ADDENDUM NUMBER 3

Project Number 89020267 TAP-3324 (411)

Project Title (Reissue) Rte. 152 Trail – Seg. 10 Pedestrian Bridge over

ISSUE DATE: 06/24/2026

**EAST WALL
 PLAN & PROFILE**

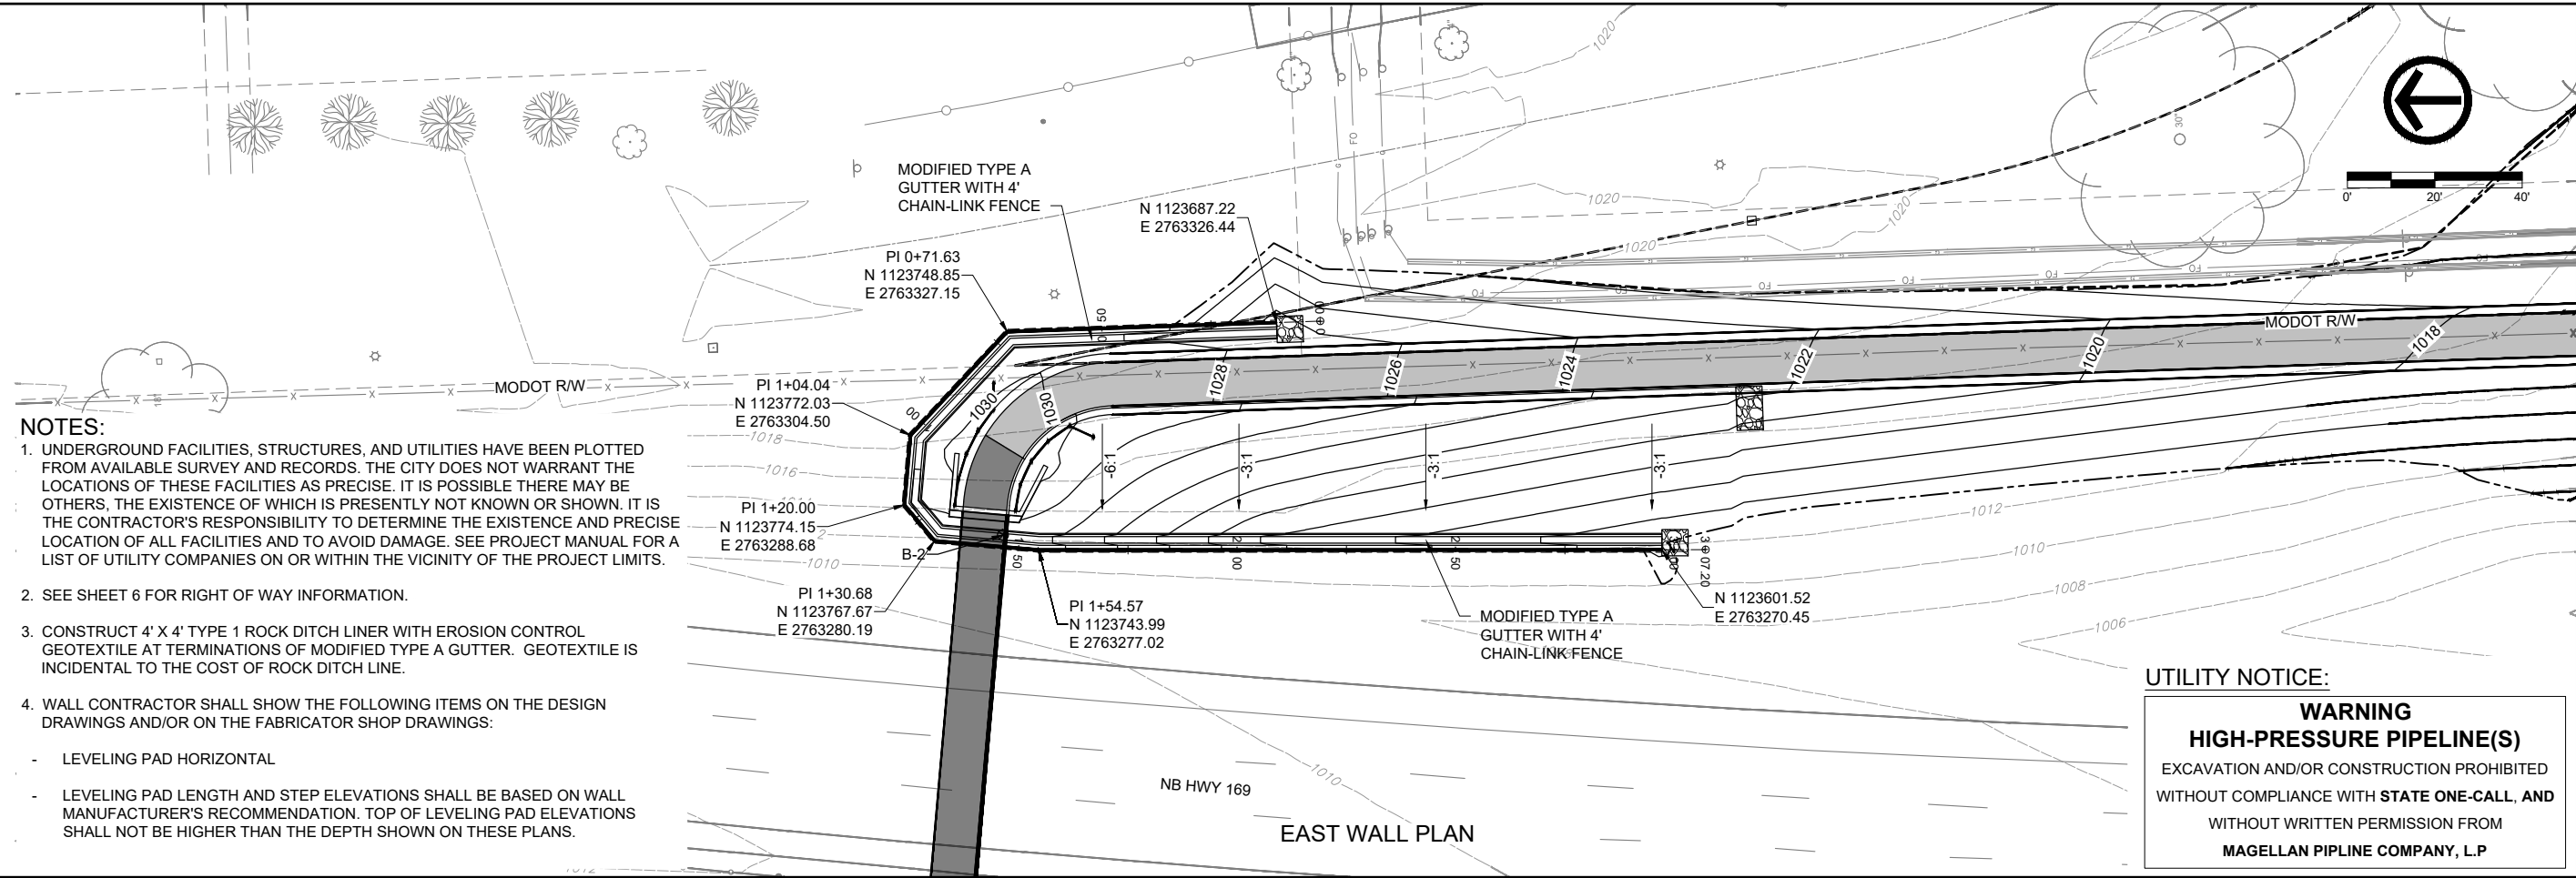
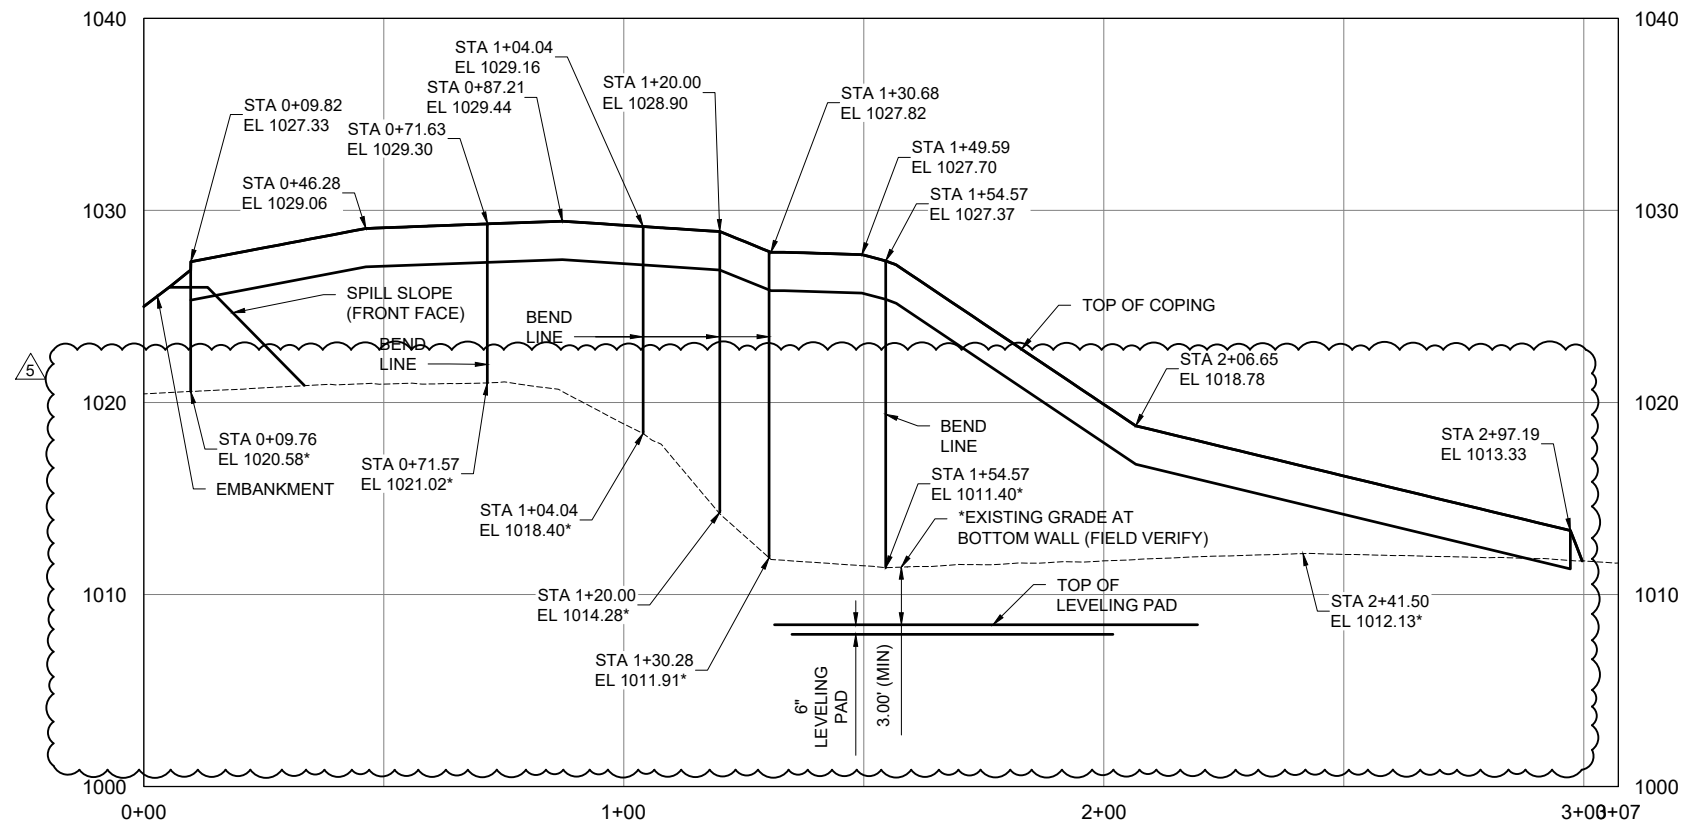
20. Can stationing and elevations for the MSE wall leveling pad and finished grade line be provided?

Please see revised plan sheets W1 and W2 depicting stationing and bottom elevations for the proposed finished grade at the wall face or top of leveling pad.

Leveling pad elevations are set by the manufacturer based on an economic arrangement of the wall pieces. Contractors are to place the depth based on the parameters set on the plans. Also, the "proposed" groundline is the "existing" groundline and the contractor should verify it since it has been years since it was surveyed. (See Page 5 and Page 6 for W1 East Wall and W1 West Wall)

DATE	DESCRIPTION
06-08-2026	ADDENDUM 5 - EX. GRADE CALL-OFFS ADDED
